## DART SERVICE INSTRUCTION

TO AMEND INSTALLATION INSTRUCTIONS IIN-D412-814 REV. C AND INSTRUCTIONS FOR CONTINUED AIRWORTHINESS ICA-D412-814 REV. 2 OR LATER APPROVED REVISIONS **REF TCCA STC: SH12-37**

#### 1.0 **PURPOSE**

FIGURE 2 - D412-814-219 REPLACEMENT BUBBLE WINDOW KIT FOR D412-814-019 S/N 168968 ONLY

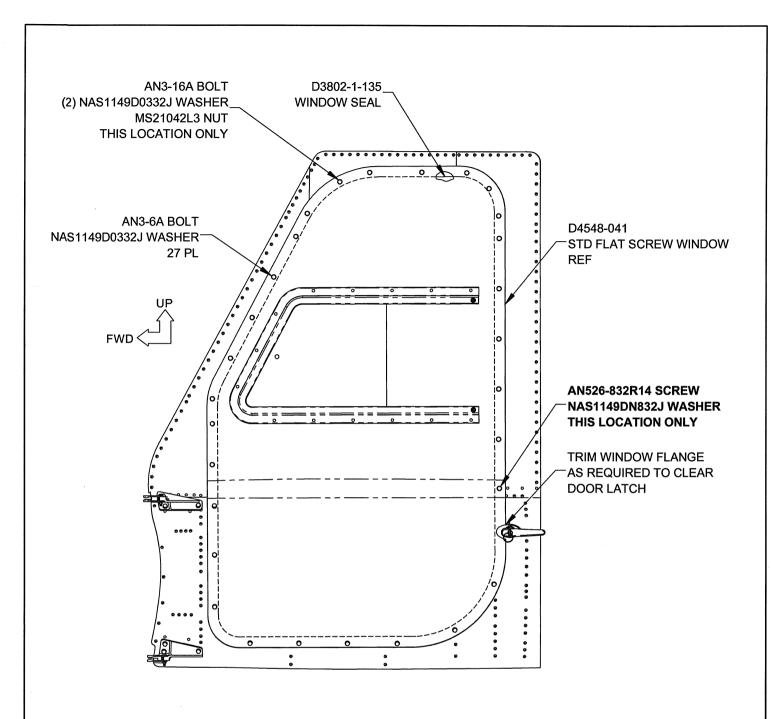
The replacement bubble window for D412-814-019 S/N 168968 is the D412-814-219 kit. The part list in section 7.0 (pg. 29) of IIN-D412-814 Rev C and section 52.16 (pg. 37) of ICA-D412-814 Rev 2 is modified as shown below. See Figure 2 of this service instruction for reference.

#### IS:

····	,	 ,	 1		
				ν		
				27	AN3-6A	BOLT
				1	AN526-832R14	SCREW
				29	NAS1149D0332J	WASHER
				1	NAS1149DN832J	WASHER
				_1

#### WAS:

_\_		
		-		28	AN3-6A	BOLT
				30	NAS1149D0332J	WASHER
				_1
